SUNDRY NOTICES AND REPORTS ON WELLS ^{OCD Artesia}
Do not use this form for proposals to drill or to re-enter an abandoned well. Use form 3160-3 (APD) for such proposals.

8. Well Name and No.
TODD 23J FED 2

PROPOSED PLUG & ABANDONMENT

Permanent Abandonment of Federal Wells
Conditions of Approval (LPC Habitat)

CURRENT WELLBORE

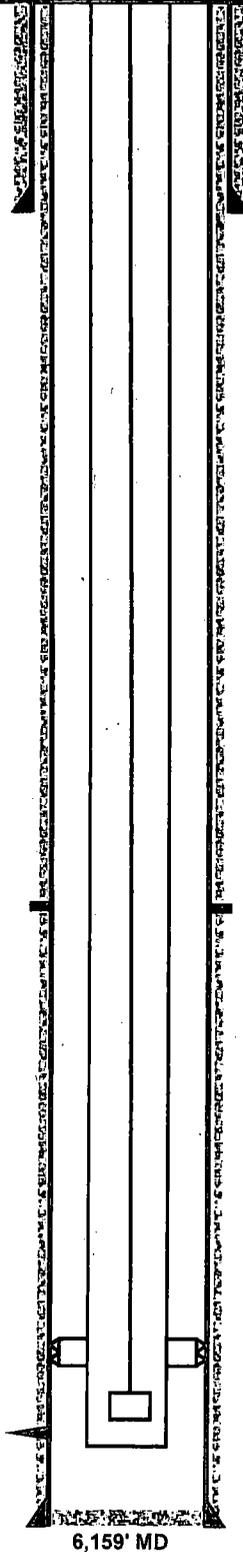
- MIRU P&A unit.
- Pull rod pump assembly and 2-3/8" production tubing from 5,964'.
- Set CIBP @ 6,000' Tag. Circulate 10# salt gel mud. *5988*
- Spot 25 sx (240') Cl C @ 6,000' - 5,760'. *5988 - 5788*
- Circulate 465 sx Cl C from 4,445' to surface. (T.Delaware 4395'; dv tool 4305'; B.Salt 4180'; T.Salt 910'; Well inside R-111P Potash)
- Cut wellhead off 3' BGL. Set dry hole marker.

Below ground level dry hole marker required
